Subject: Planning Application for Garden Office - 13 Chalcot Gardens NW3 4YB - 13 Chalcot Gardens: 2024/4823/Proposed replacement Outbuilding (Garden Studio) within the rear garden

Re: 13 Chalcot Gardens: 2024/4823/Proposed replacement Outbuilding (Garden Studio) within the rear garden.

This is an application to build a large Garden Studio.

Figure 1. Garden Studio Proposal and scale as shown in application. (Ref pg. 11)

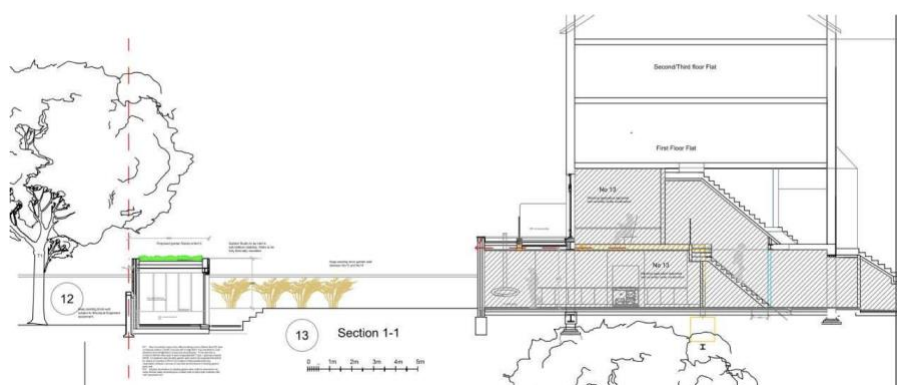
The Garden Studio is set 10m from the main residences and facing the residences and as outlined in Policy A1 Section 2.4 this condition is not met. Further to this the nature of the low boundary walls, which is in the character of the Conservation Area and Gardens, will mean inevitable overlook. Please see Figure 1 below for reference of distances as per application.

Figure 3. Overlook of garden building and agreed roof terrace on neighbouring residences

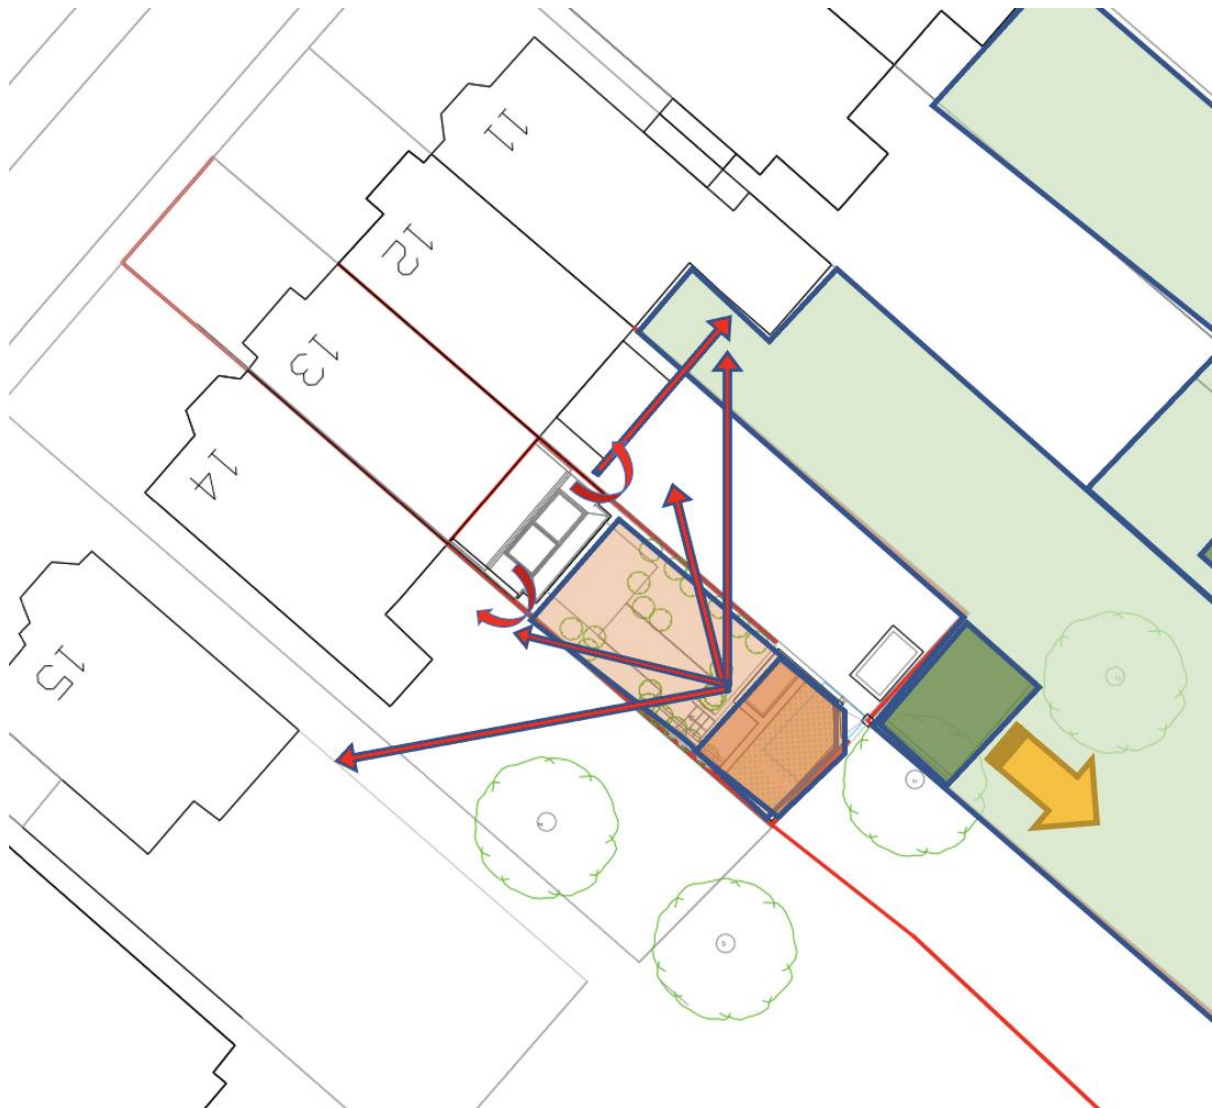
The approval of a Garden Studio in conjunction with planning for an extension already provide outlook in all directions including from the sides and directly onto resident rooms. See Figure 3 below and Images 1 to 4.

The previous outlook covered a 180-degree angle impacting privacy from the sides of residents, however with a further outlook now facing the building the cumulative outlook of both proposals in combination gives a 360-degree outlook. When the plans for the Garden Studio are added to this, neighbouring properties would now have to be blinkered by 1.7m high screening. Following the same logic, will have to have screening continuing for a further 10m to mitigate the impact on privacy. Even if it was feasible to add screening to a height of 1.7m across both boundary walls, it would still be unlikely to preserve the privacy of the remaining 4 floors in each of the affected 4 residences (16 floors and 4 balconies No. 10, No. 11, No. 13, No. 14). The remaining outlook of the proposed Garden Studio would still be the upper residential windows even if a screen was added.

Figure 5. A large portion of the boundary wall is raised.

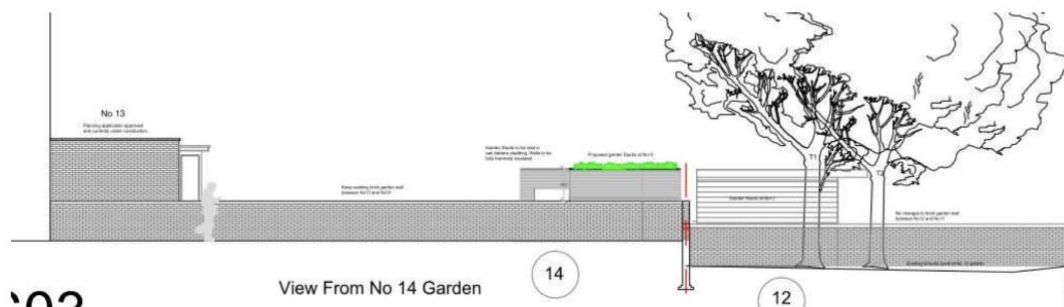
Further to the erosion of the garden space the erection of high walls on either side take away from the character of the conservation area defined by low boundary walls which allow for a sense of openness and the free movement of local wildlife (see Figure 5). The Garden Studio proposal is also wall to wall and effectively hermetically seals the Garden in no. 13 from the other gardens impacting the nature of the conservation area and the movement of wildlife (see Figure 6). The above statement is echoed in the Official Planning Guidance on Design : Paragraph 4.41 of which the sections states:
